BINARY INPUT INTERFACE

BINARY INPUT INTERFACE TOP LEVEL

64 Channel Binary Input Card
D1001036
Version 3

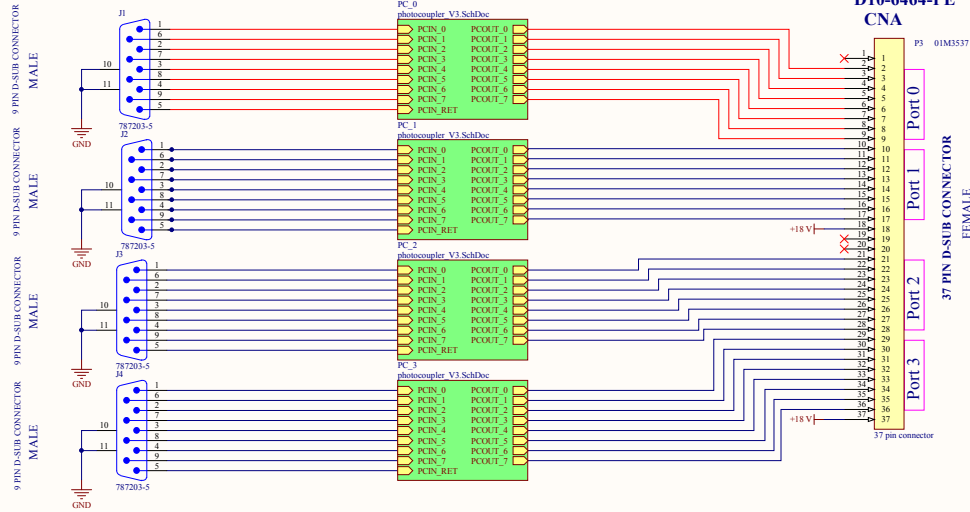
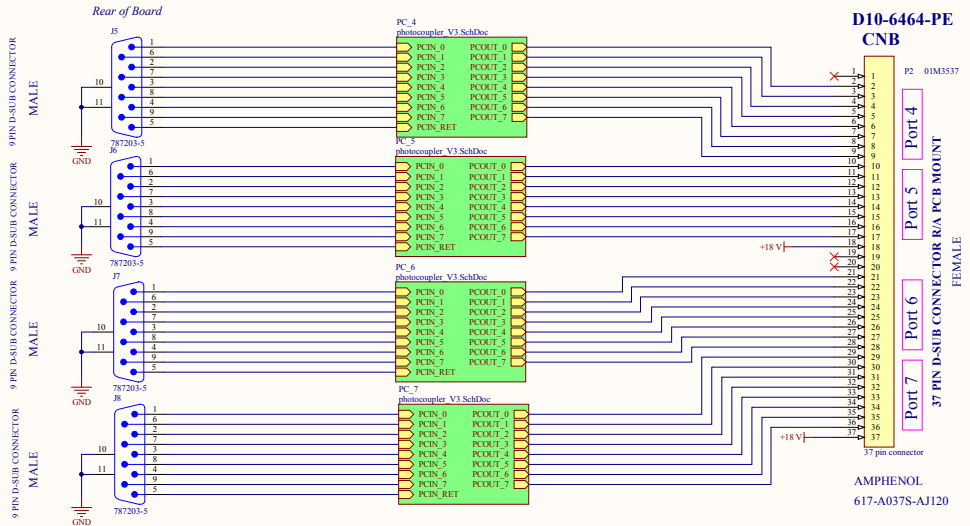
NOTES:
VC CHANGES
Corrected mounting hole to plated through holes
Added pull back on poly plane pours on top and bottom
Increased test width on silkscreen from 1 to 7 mil Business
Added channel identification onto silkscreen
Change board size from 16" to 14" wide
Change footprint size from 0805 to 1206, for R9
